# SERVICE BULLETIN

B-034 November 1, 2000

## **RECALL CAMPAIGN 0821 - RACE MUFFLER RETENTION KIT**

Figure 1. Installing Retention Cable and Clamp

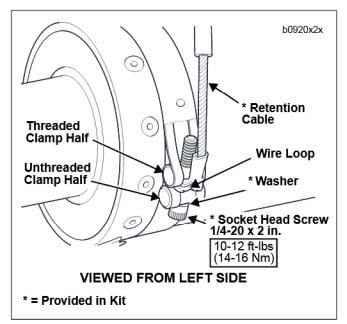
- 2. Disconnect negative battery cable from battery terminal.
- See Figure 1. Using a Scotch-Brite pad, thoroughly clean front portion of muffler where clamp will be installed.

- See Figure 2. Position new clamp on front of muffler so clamp hardware will be located on outboard side.
- 7. See Figure 1. Install new socket head screw and washer from bottom through unthreaded clamp half. Position retention cable wire loop between two clamp halves and finish installing socket head screw through wire loop and the threaded clamp half. NOTE: When properly installed, there should be no tension on the cable.

- See Figure 1. Tighten clamp screw to 10-12 ft-lbs (14-16 Nm).

Figure 2. Retention Cable Installed

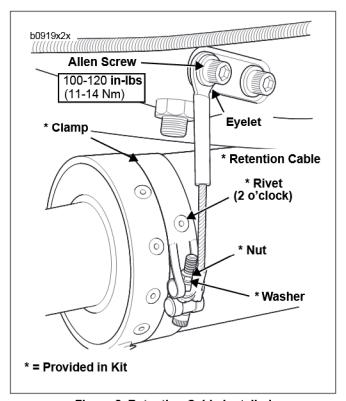
- See Figure 2. Remove front allen screw on left lower side
  of the primary cover. Install retention cable eyelet with
  front allen screw finger tight. NOTE: On X1 models or
  models equipped with chin fairings, remove spacer
  between chin fairing and primary cover.

- Remove front allen screw and retention cable eyelet from primary cover to allow access for performing steps 10-13.
- See Figure 2. Install hex nut and washer to clamp screw and tighten nut.

- 11. Using a center punch, dimple the muffler at the center of the pre-drilled clamp hole at the 2 o'clock position.
- 12. See Figure 2. Using a #11 drill bit (0.190 in.), drill through the muffler at the 2 o'clock position.
- 13. Using a pop rivet gun, install rivet provided in kit to locate clamp on muffler.
- 14. See Figure 2. Install retention cable eyelet to primary cover with allen screw. On X1 models or models equipped with chin fairings, remove 0.120 in (3 mm) of material from inboard (non-stepped) side of spacer with a lathe or file. Reinsert spacer between eyelet and chin fairing, stepped side outboard. Eyelet will be located between the primary cover and the spacer. Tighten allen screw to 100-120 in-lbs (11-14 Nm).
- Connect negative battery cable to negative battery terminal. Tighten to Service Manual specifications.
- 16. See CREDIT PROCEDURE.
